Technical Service Bulletin

GROUP	NUMBER
ENGINE	24-EM-001H
DATE	MODEL(S)
JULY 2024	SONATA (DN8a) SANTA FE (TMa) TUCSON (NX4a)

SUBJECT: DTC P2181 – INTEGRATED THERMAL MANAGEMENT (ITM) REPLACEMENT

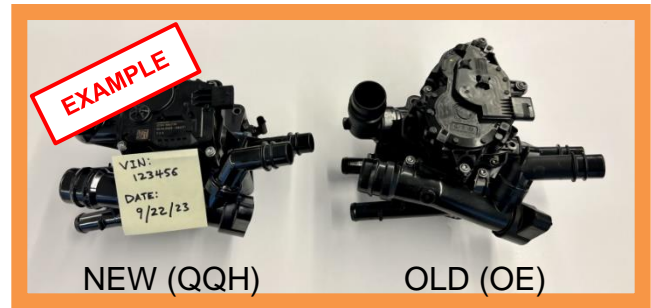
1. Confirm with GDS scan tool that DTC P2181 “Cooling System Performance” condition exists.
 - ❖ This TSB only applies if DTC P2181 condition exists.
2. If DTC P2181 is present, replace the existing ITM with the revised ITM (P/N 25600-2S001QQH).
 - **Shop Manual:** Engine Mechanical System > Cooling System > Integrated Thermal Management > Repair Procedures
